BROWNS FERRY NUCLEAR PLANT (BFN) - UNITS 1, 2, AND 3 - TECHNICAL SPECIFICATIONS (TS) CHANGES TS-431 AND TS-418 - EXTENDED POWER UPRATE (EPU) - RESPONSE TO ROUND 12 REQUEST FOR ADDITIONAL INFORMATION (RAI) - (TAC NOS. MC3812, MC3743, AND MC3744)

**TENNESSEE VALLEY AUTHORITY
BROWNS FERRY NUCLEAR PLANT (BFN)
UNITS 1, 2, and 3**

**TECHNICAL SPECIFICATIONS (TS) CHANGES TS-431 AND TS-418
EXTENDED POWER UPRATE (EPU)**

**RESPONSE TO ROUND 12 REQUEST FOR ADDITIONAL INFORMATION
(NON-PROPRIETARY INFORMATION VERSION)**

Figure SBWB-59-2

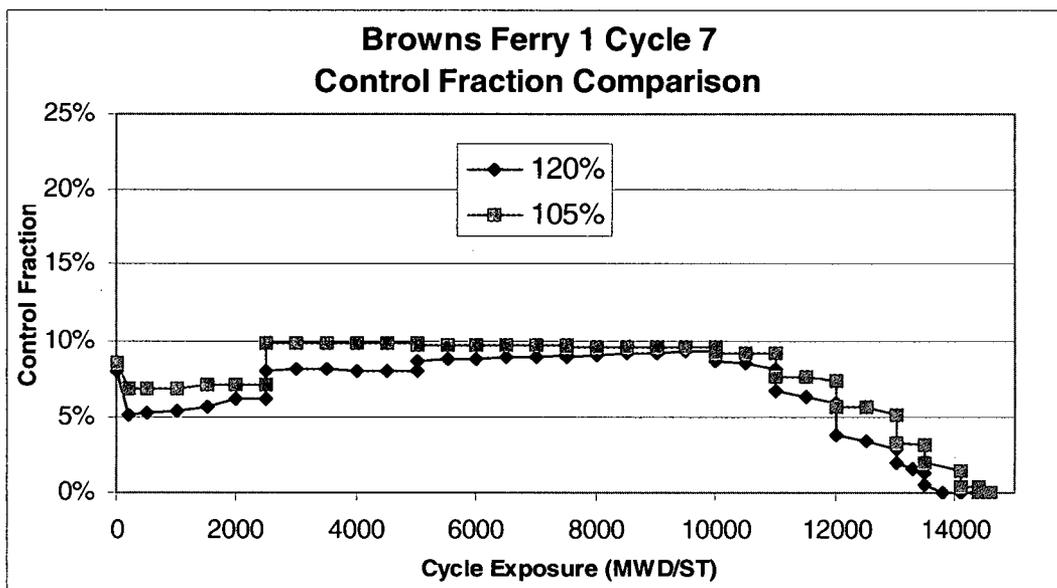
Since there is no specific operational plan for Cycle 7, explain how the maximum decrease in the shutdown margin (SDM) at cycle exposures other than beginning-of-cycle (e.g., R value) will be

calculated before the restart of the plant. Address whether the R value will be calculated for the assumed operation at 105 percent and at 120 percent, or if the SDM calculation will be revised based on the actual operational plan.

- a. Provide the rod density and the R value for the SDM calculation, based on the combined power level operation.
- b. Discuss if the operation at the lower power level will decrease the additional design SDM (e.g., the 1.5-percent design margin for EPU), considering the CR patterns and the power distributions expected relative to the projected EPU operation.
- c. Provide a comparative assessment of the components of the design SDM to show that operation at the lower power level will not result in lower available design margin to account for potentially higher modeling uncertainties. Specifically, provide assurances that the control of the additional reactivity through deep CRs for operation at the lower power levels will not result in a higher CR worth, such that the additional design margin is reduced.

Figure SBWB-59-1 shows the R-value for the core operating at both 105% and 120% power. The core loading is the same for both reload analyses, and because the void and control history impact is negligible, the SDM results are nearly identical. Since SDM is evaluated for operation at both power levels, the two reload analyses bound the effects of power level and power shape for actual operations. The core average control rod fractions at hot operating conditions for the 105% and 120% core power are provided in Figure SBWB-59-2.

- a. The R-value and core average control rod fraction for the 105% OLTP and 120% OLTP reload analyses are provided in Figures SBWB-59-1 and SBWB-59-2, respectively. The minimum cold SDM based on 105% operation is slightly lower than for EPU operation; however, the minimum SDM is still maintained above the 1.5% design goal for both power levels.
